RE: NRC Docket 40-06563,  
License STB – 401  
License Amendment to Remove URO from Plant 6W – Response to RAIs and  
Removal of Burial Pit #10

## NRC RAI CONCERNING THE TECHNICAL BASIS FOR MAXIMUM ACCEPTABLE SURFACE CONTAMINATION

Figure 1. Uranium-to-Thorium Ratio in URO and Adjacent Soil in Plant 6W

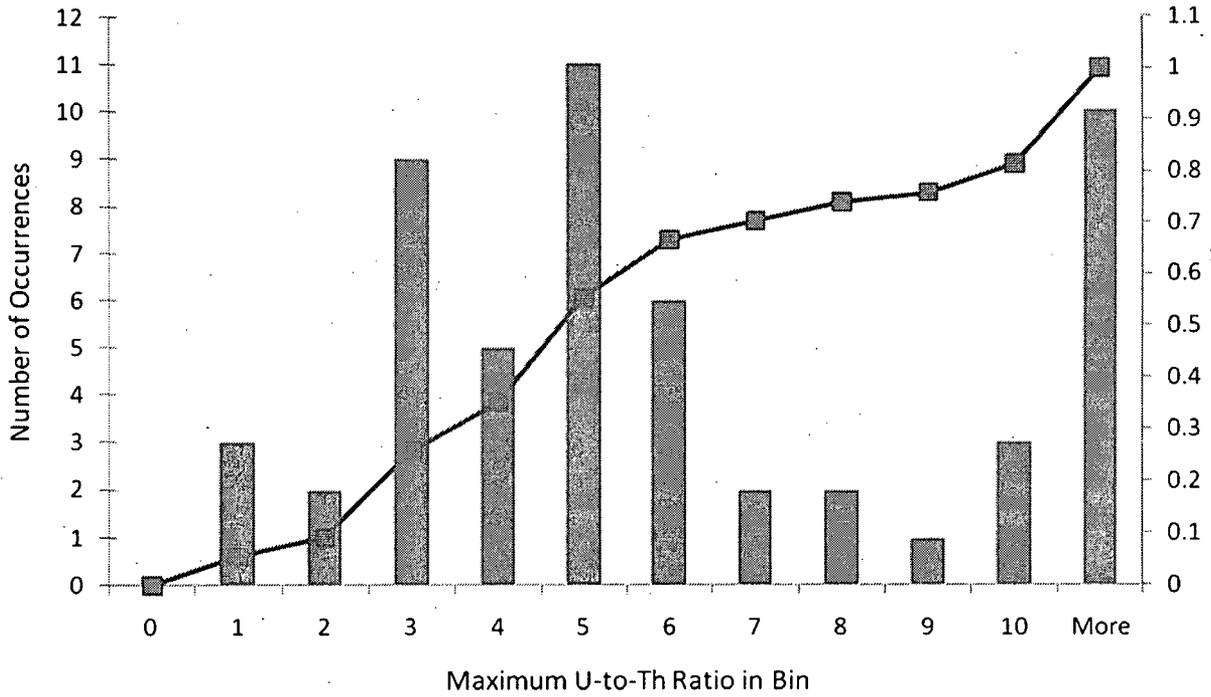
Please provide the bases for the surface contamination Derived Concentration Guideline Level (DCGL) for equipment release surveys in Table 6-4. The license amendment request proposes 2400 dpm/100 cm<sup>2</sup>. Mallinckrodt should explain the basis for 2400 dpm/100 cm<sup>2</sup> or to demonstrate (by RESRAD-BUILD, etc.) that 2400 dpm/100 cm<sup>2</sup> will not exceed the applicable dose criteria.

More recent measurements of U series and Th series in URO and in adjacent soil in Plant 6W were proposed as bases of a derivation of maximum acceptable areal contamination on equipment associated with the URO project and subject to removal from Plant 6W. The uranium-to-thorium ratio and the U<sup>238</sup>-to-Th<sup>232</sup> ratio in each sample were calculated. An histogram of the distribution of U<sub>nat</sub>-to-Th<sub>nat</sub> is Figure 1 and of U<sup>238</sup>-to-Th<sup>232</sup> is in Figure 2 herewith. In these histograms, U-to-Th ratios in URO and adjacent soil samples were combined into one population; for the numbers of samples are roughly proportionate to the amount of URO and adjacent soil to be excavated and thus to the potential contamination by either URO or adjacent soil, or a mixture of the two.

Three or four of the samples exhibit U<sub>nat</sub>-to-Th<sub>nat</sub> or U<sup>238</sup>-to-Th<sup>232</sup> ratio less than one and those were of URO. However, the histograms also indicate that they comprise only about 6 or 7% of the total population of samples. Samples exhibiting a ratio no greater than two comprise only about 10% of the total population of samples. Overall risk of equipment being contaminated by U<sub>nat</sub>-to-Th<sub>nat</sub> radioactivity ratio less than two is thus relatively low.
